Groundwater Application Review Summary Form

Application # G- 19250

PUBLIC INTEREST REVIEW FOR GROUNDWATER APPLICATIONS

A. GENERAL INFORMATION: Applicant's Name: Rob Wallace, Del Rio Vineyards County: Jackson

Well Location Map

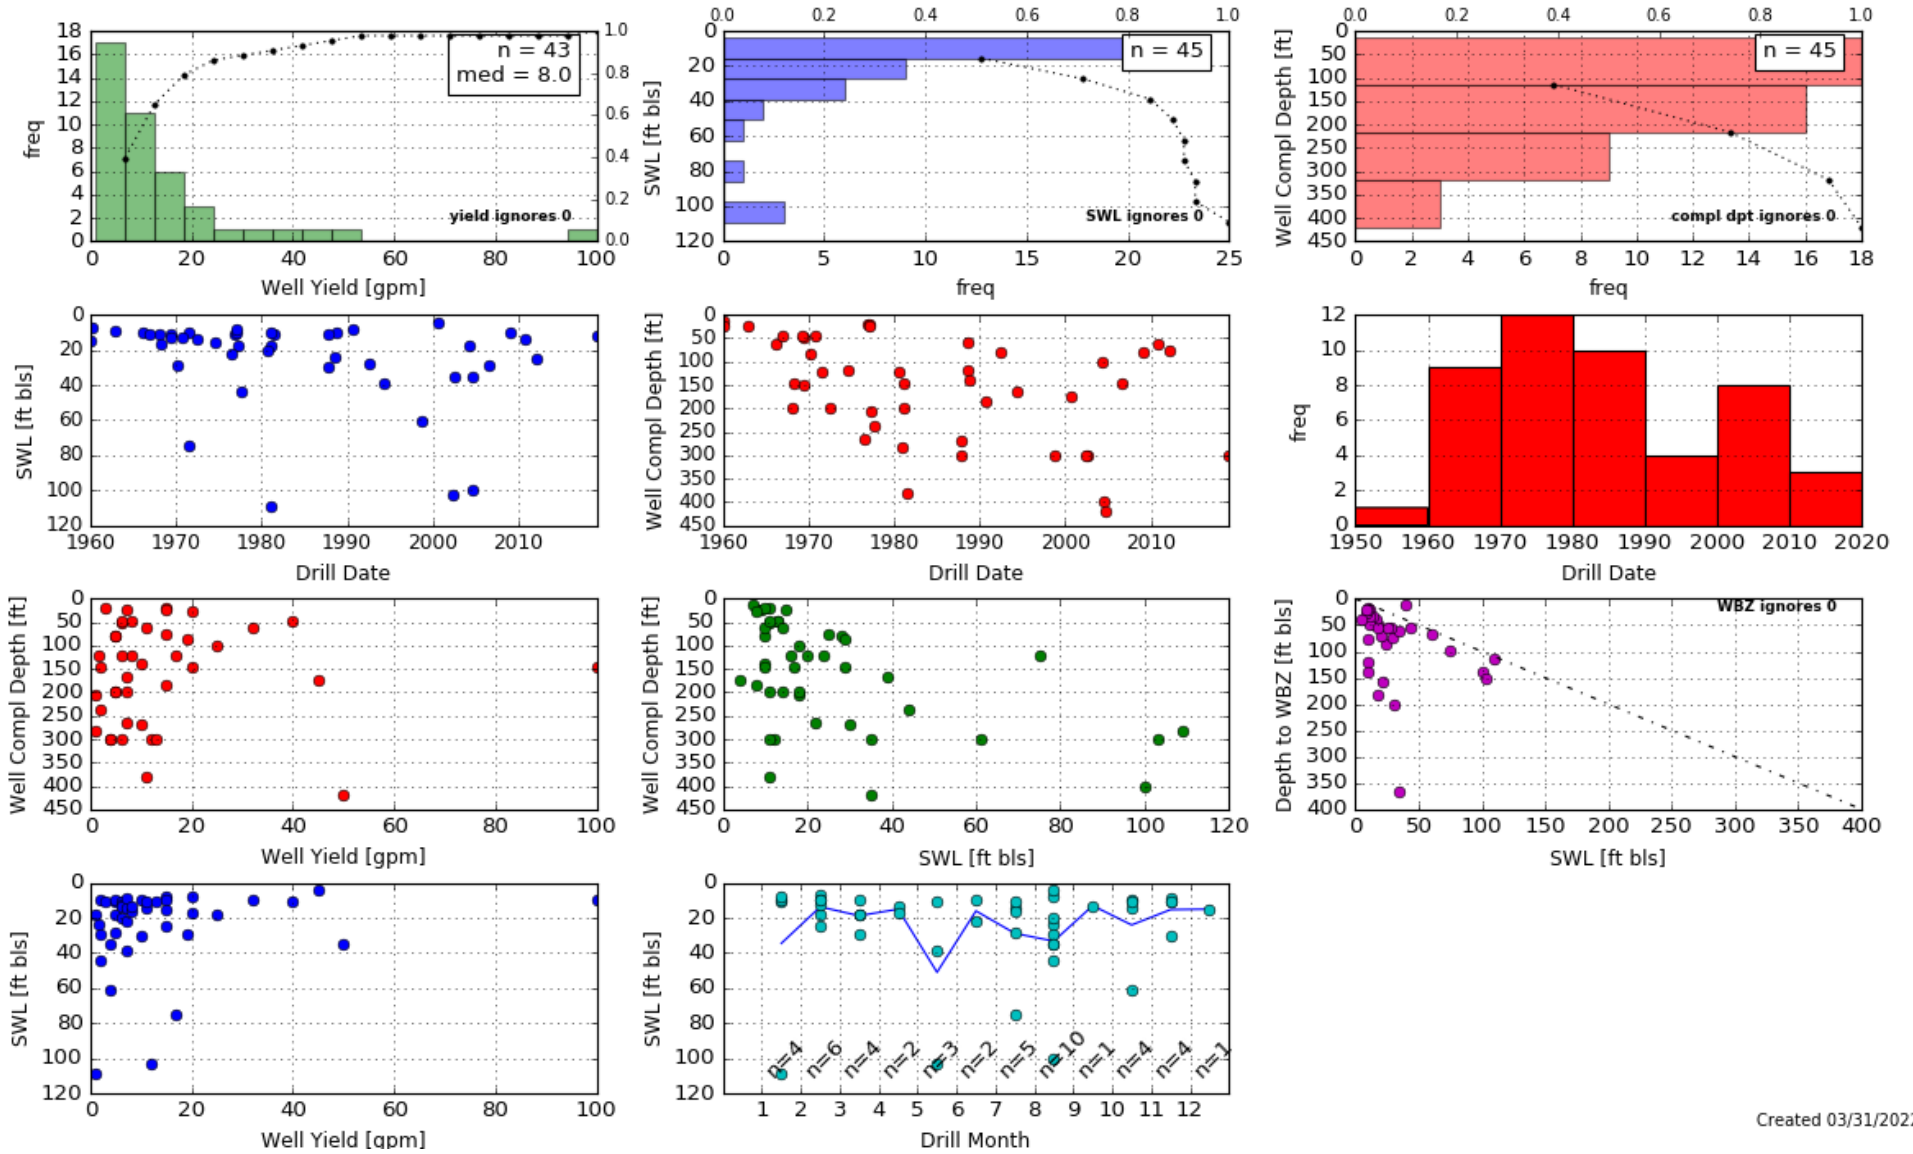
B3. **Groundwater availability remarks:** Based on the proposed location/construction and best available geologic mapping, the applicant’s well would be cased and sealed through 5-30 feet of Quaternary-aged sediment and then access a fractured-rock aquifer hosted in secondary porosity of the Payne Cliffs Formation (Wiley et al 2011). There are no OWRD observation wells constructed in the target aquifer within several miles, so over-appropriation cannot be determined. Well reports filed in adjacent TRS 36S/2W sections 10, 11, and 12 show that 1) water levels are predominately shallow (median reported SWL = 15 ft bls), 2) well yields typically decrease beyond depths of ~200 feet bls), and 3) well yields are predominately low (median yield = 8 gpm, 13% with yield > 20 gpm). The requested rate of 1.85 cfs or 830 gpm is much greater than any well accessing the target aquifer. Because of the yield-decrease with depth and the relatively low permeability and storativity, constructing a deep, larger-diameter well is not expected to substantially increase well yield beyond what has been observed.

Adjacent tax lots to the west are likely supplied by exempt-use domestic wells, which may experience well-to-well interference from the proposed use. Theis (1935) distance drawdown modeling indicates that the proposed use would cause 75 to 700 feet of seasonal drawdown in the closest wells (tax lots 400 and 600). These results indicate that 1) the requested rate/volume exceeds the capacity of the aquifer and 2) that a well field of many lower yield wells adding to the requested rate/volume would very likely injure adjacent water users. Because these exempt-use wells produce water from a fractured rock aquifer, they are not required to fully penetrate the aquifer to satisfy the conditions of Substantial or Undue Interference (SUI). As such, the proposed use would likely injure adjacent groundwater users. Because of the magnitude of expected well-to-well interference and the high requested rate, the proposed use is found to be not within the capacity of the resource.
